## Change Order #6 Las Milpas Road

Project: Las Milpas Road  
Contract: C-22-0094-09-06(ARPA 22-1-122-109)  
Limits: McColl Rd (FM 3062) to 10<sup>th</sup> Street (FM 336)

### Summary of Change Order No. 6 (CO#6)

# CONSTRUCTION CONTRACT CHANGE ORDER NUMBER: 6

**LAS MILPAS ROAD IRRIGATION LAYOUT**  
STA. 116+40

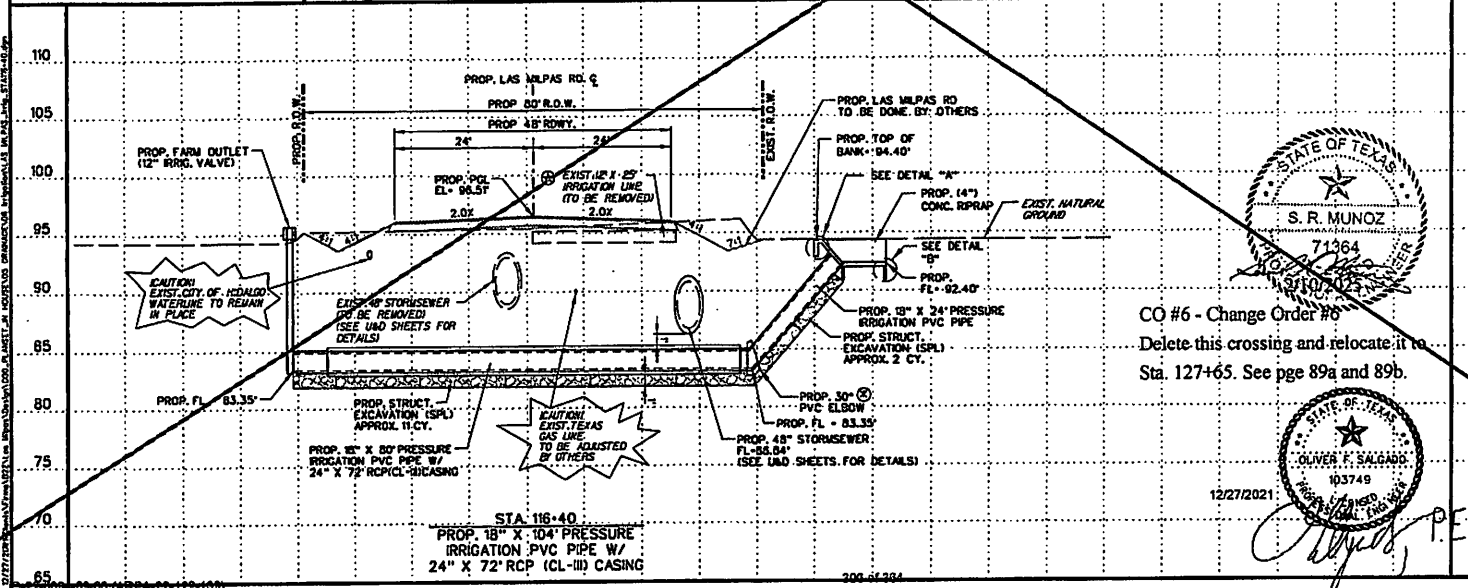
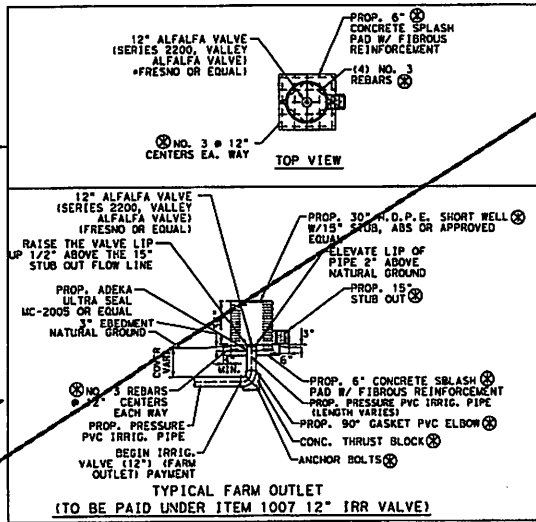
CO #6 - Change Order #6  
Delete this crossing and relocate it to Sta. 127+65. See pgs 89a and 89b.

**LAS MILPAS ROAD**  
**IRRIGATION CROSSING**  
**STA. 116+40**

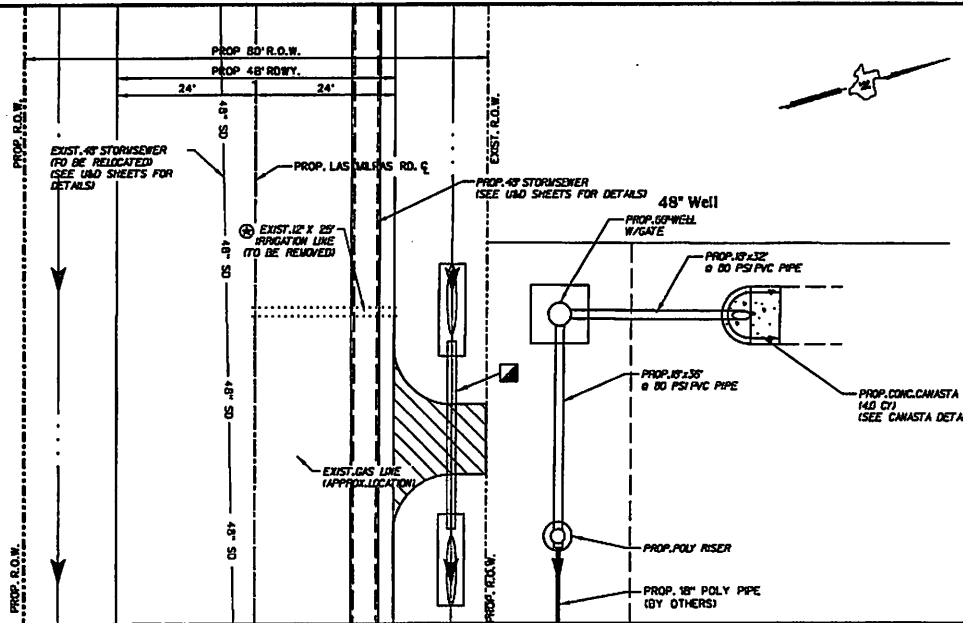
**CO #6 - Change Order #6**  
**Relocate the irrigation crossing**  
**at Sta 116+40 to Sta 127+65**  
**using poly risers and canastas.**

**LAS MILPAS ROAD IRRIGATION DETAILS**

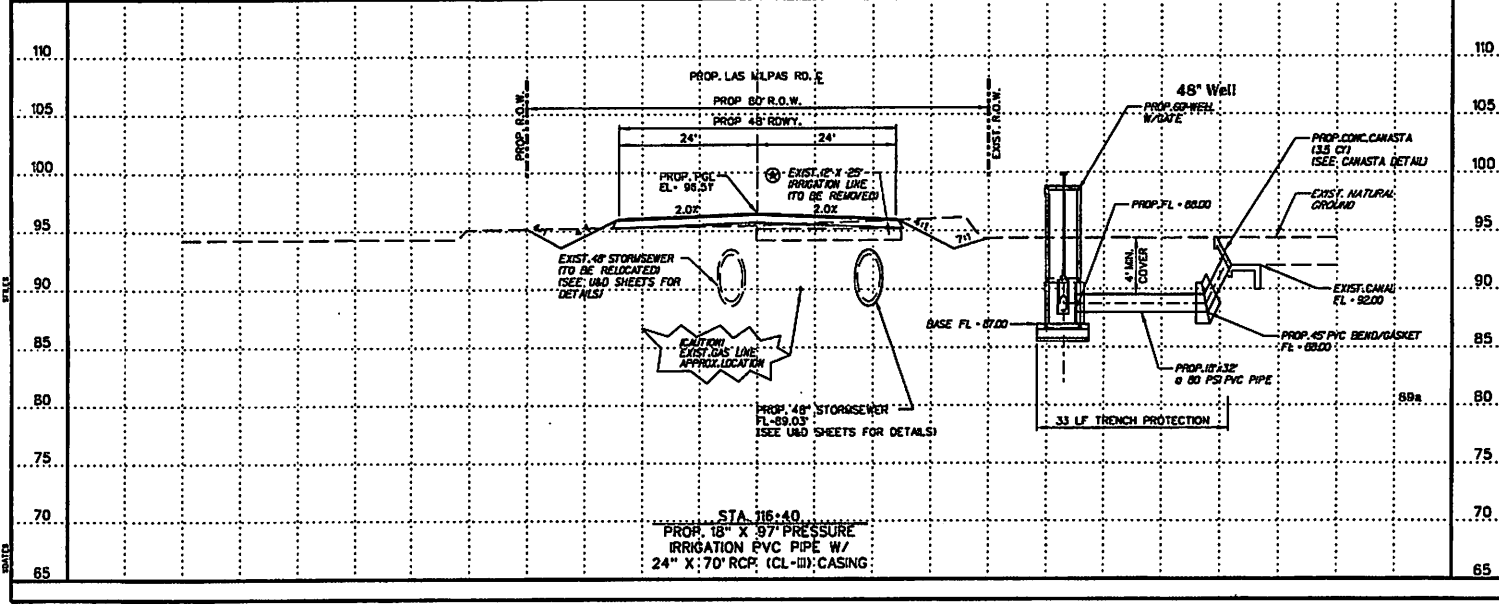
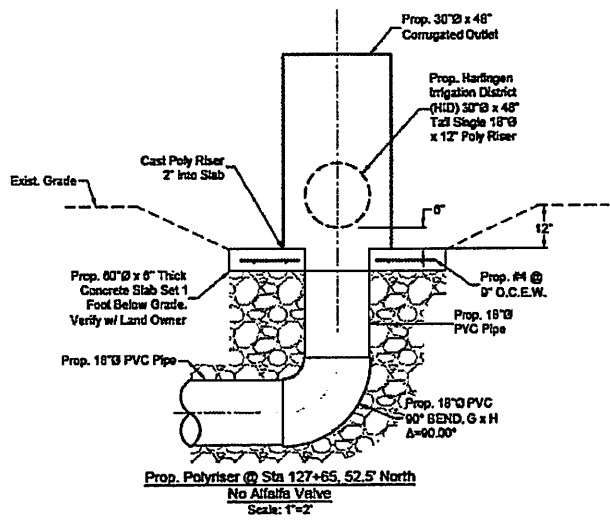
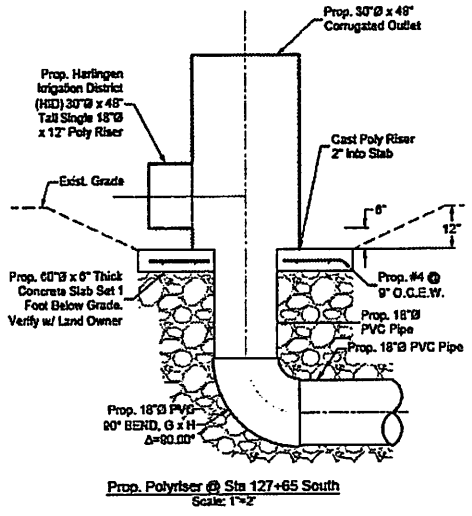
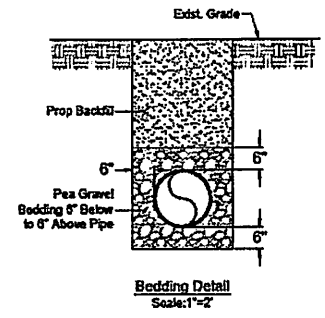
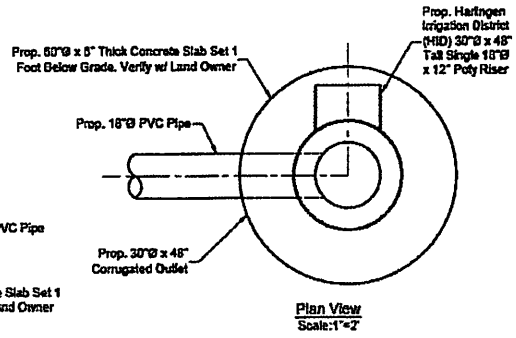
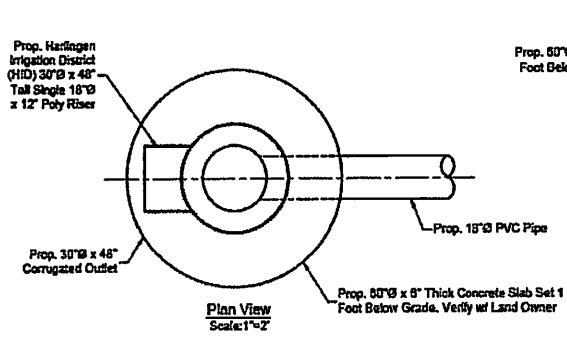
**CO #6 - Change Order #6**  
 Eliminate 1-36" well and extend the 12" Irrigation line an additional 40Lf with a poly risers. Relocate the irrigation crossing at Sta 116+40 to Sta 127+65 using poly risers and canastas.

**LAS MILPAS ROAD**  
 IRRIGATION LAYOUT  
 STA. 157-88

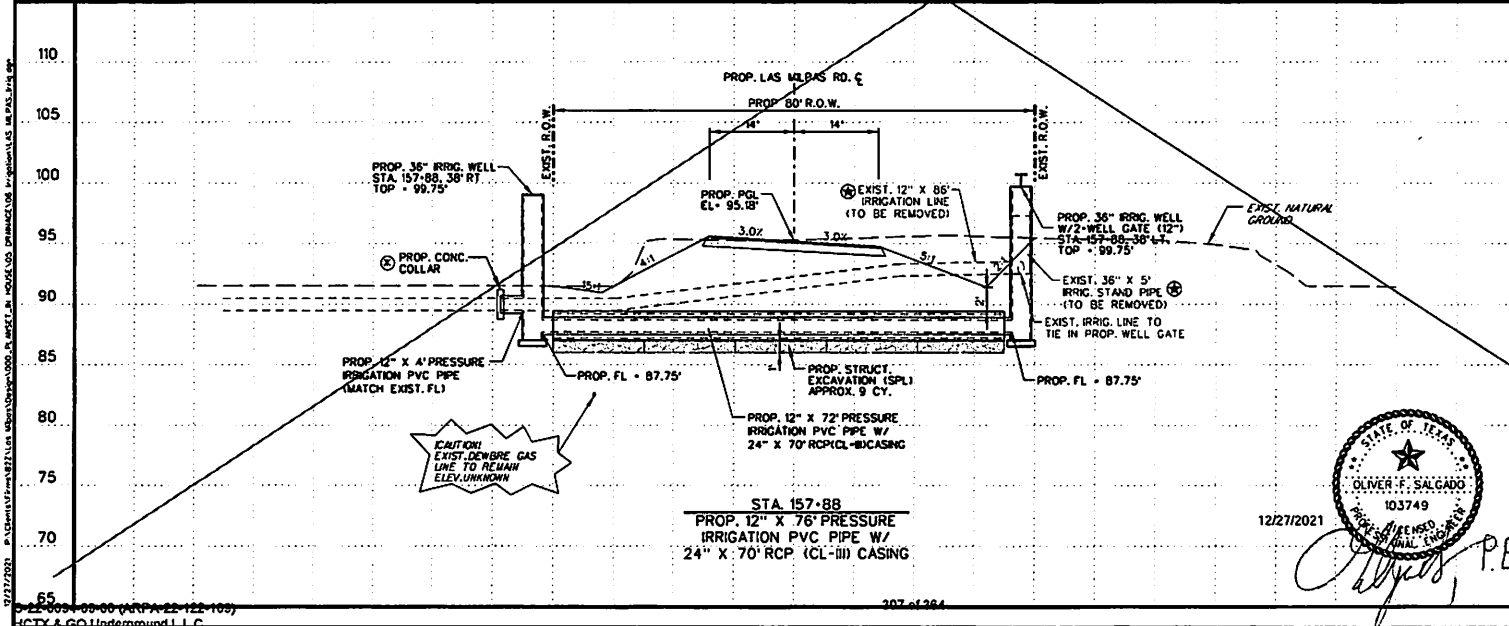
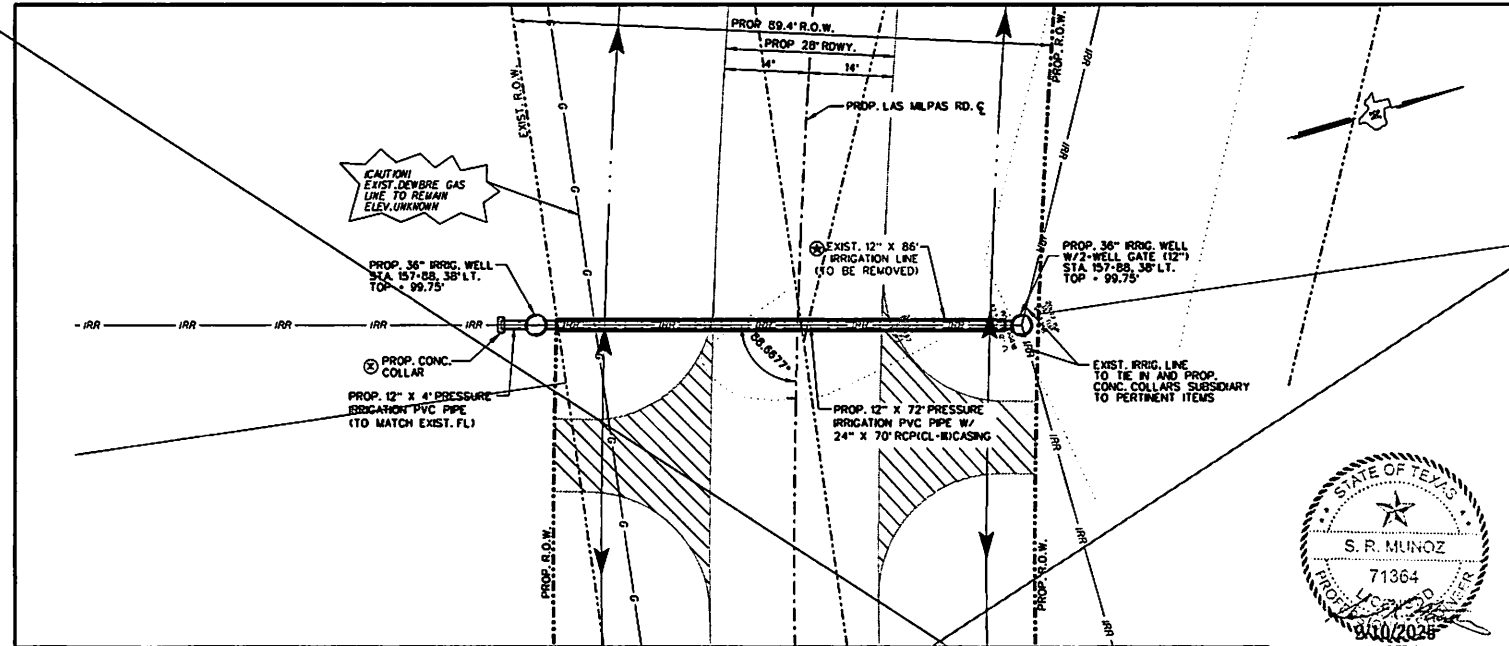
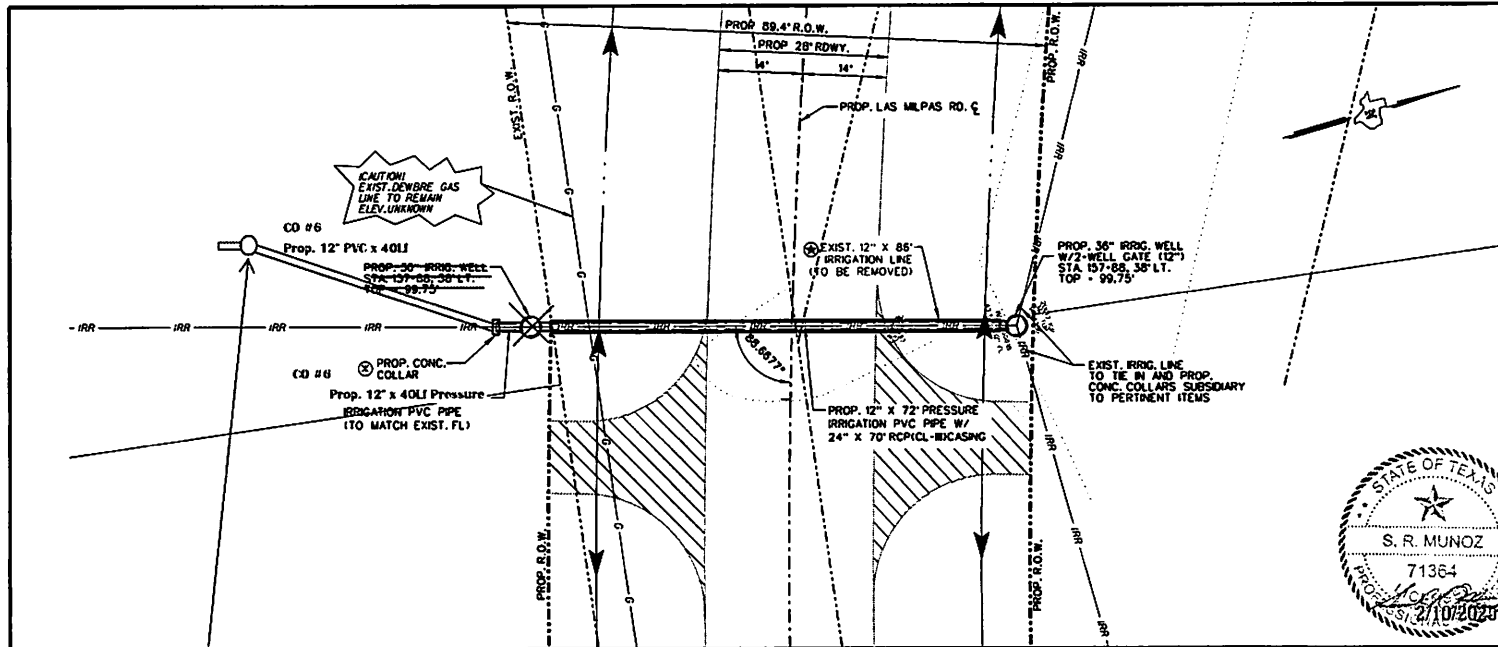
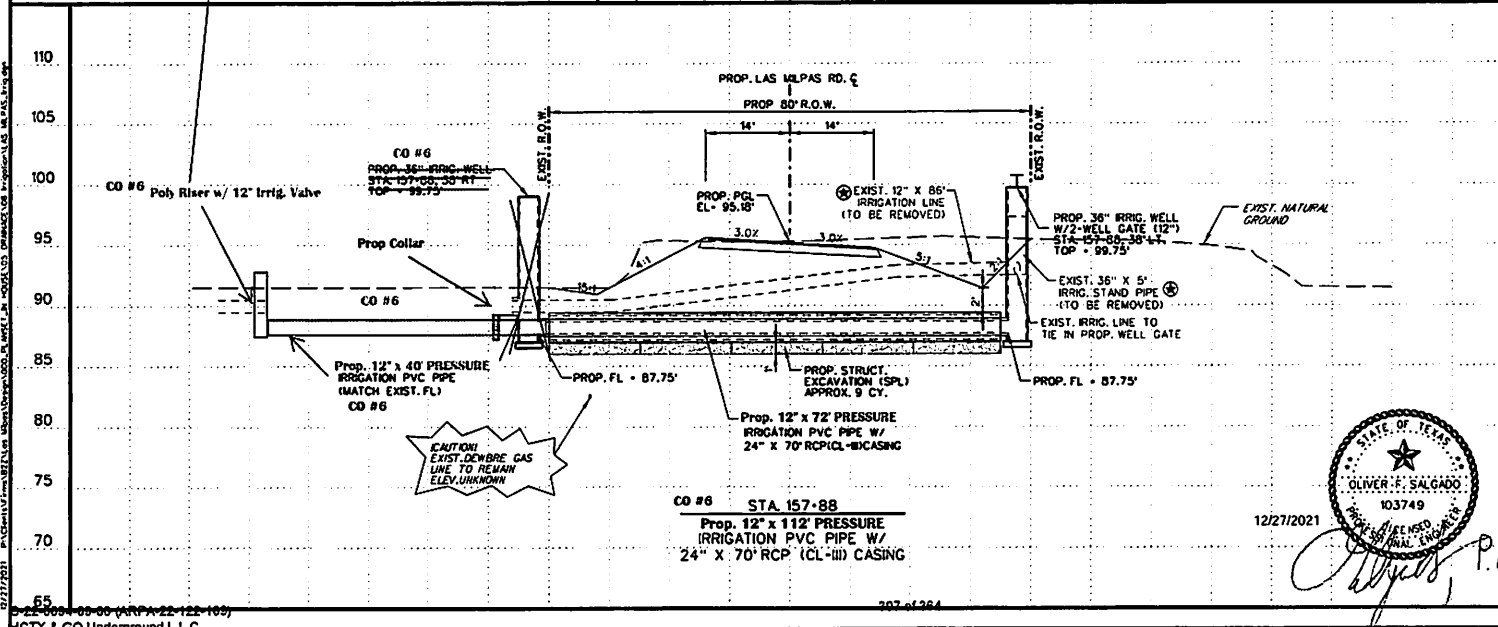
**CO #6 - Change Order #6**  
 Eliminate 1-36" well and extend the 12" Irrig. line an additional 40LF.

**LAS MILPAS ROAD IRRIGATION LAYOUT STA. 157-88**

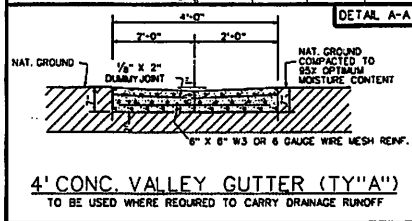
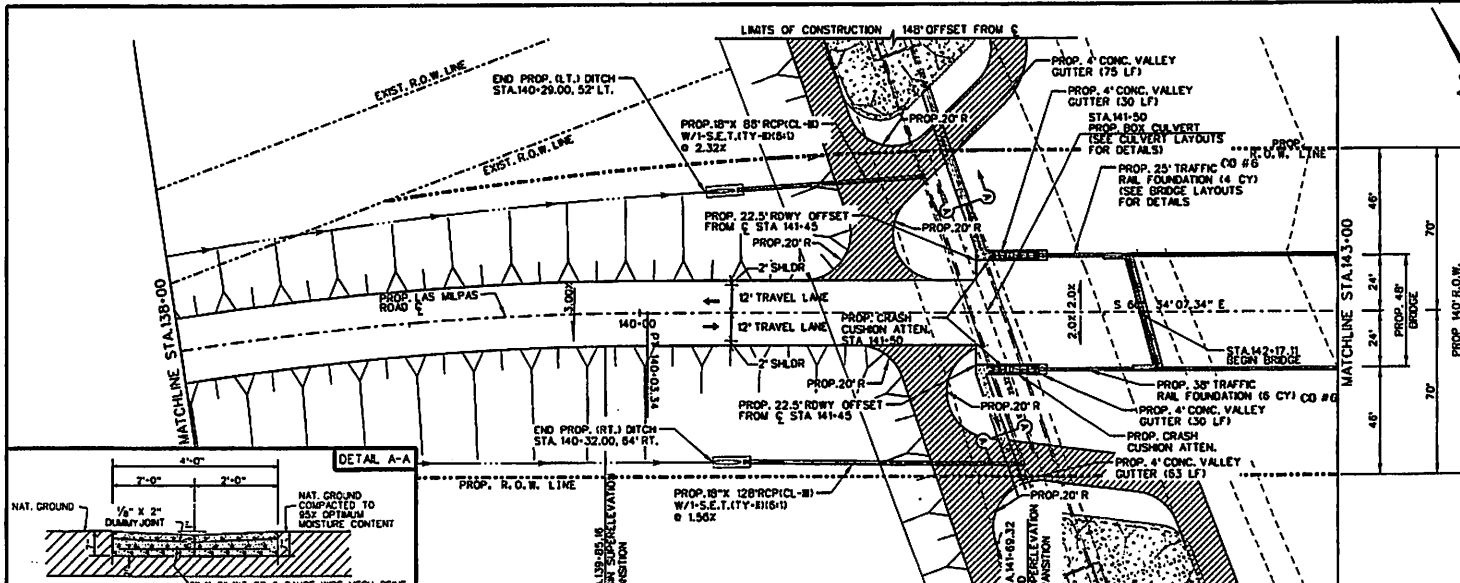
**CO #6 - Change Order #6**  
 Eliminate 1-36" well and extend the 12" Irrig. line an additional 40LF. Add concrete rail foundation.

**LAS MILPAS ROAD  
 PLAN AND PROFILE  
 STA. 138+00 TO STA. 143+00**

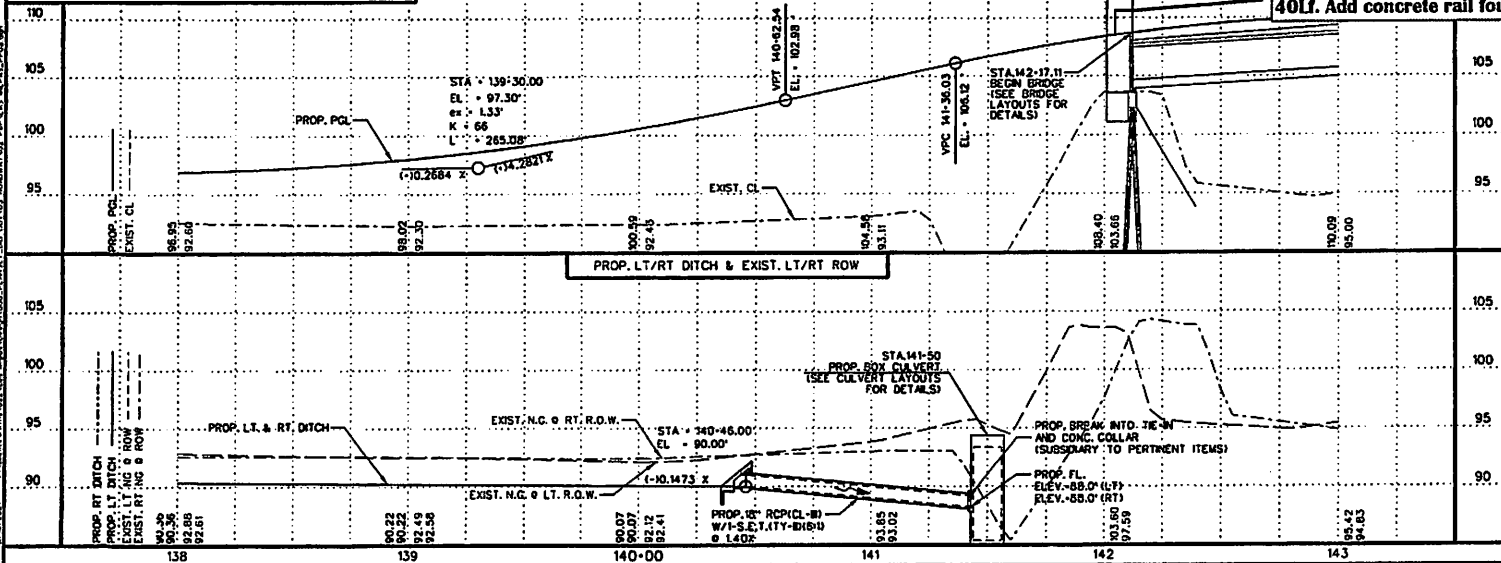
**CO #6 - Change Order #6**  
 Eliminate 1-36\"/>

**LAS MILPAS ROAD  
 PLAN AND PROFILE  
 STA. 143-00 TO STA. 148-00**

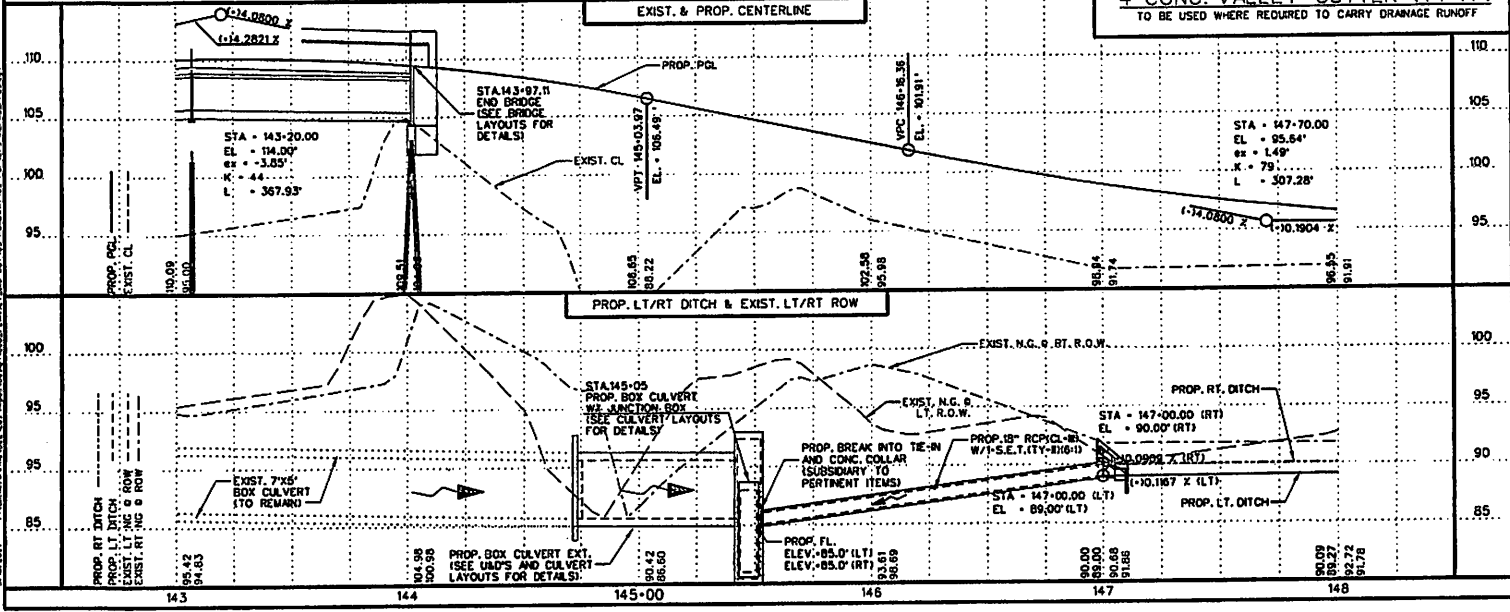
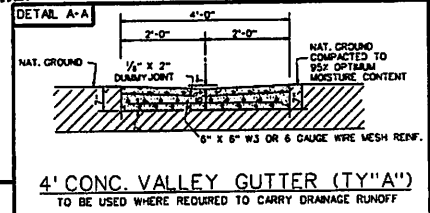
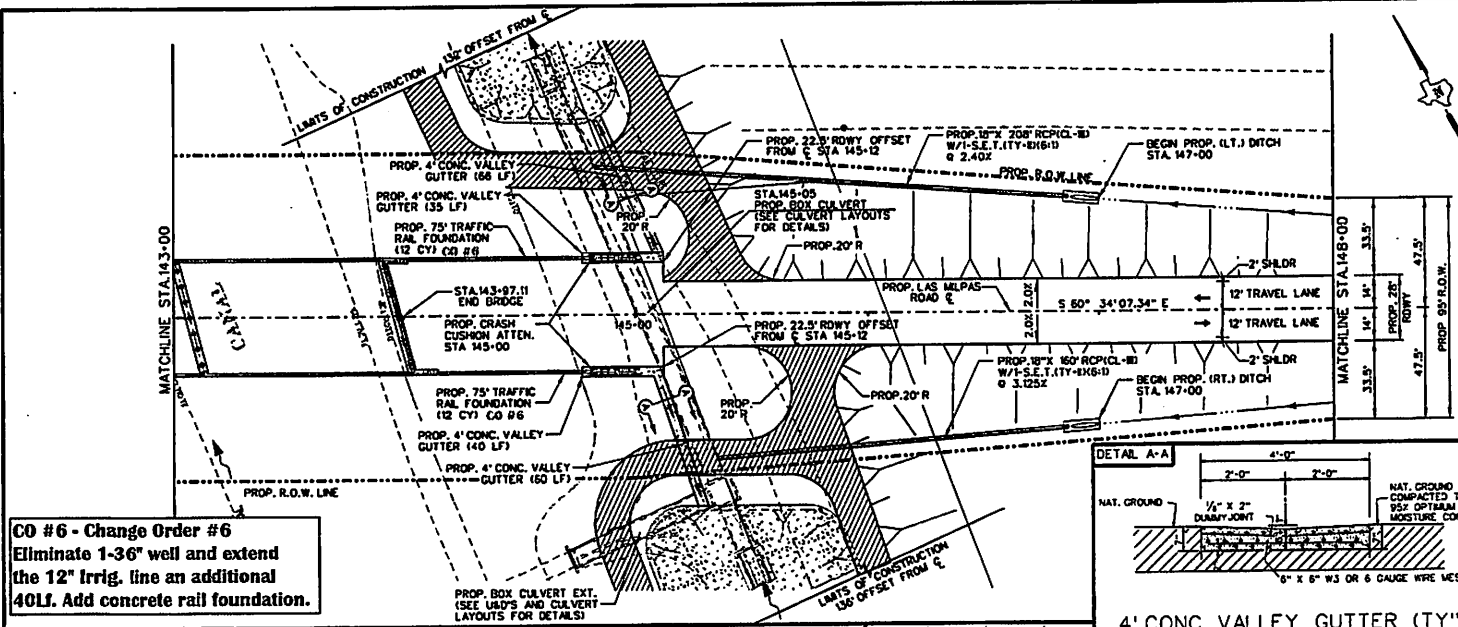
**CO #6 - Change Order #6**  
 Eliminate 1-36" well and extend the 12" Irrig. line an additional 40LF. Add concrete rail foundation.
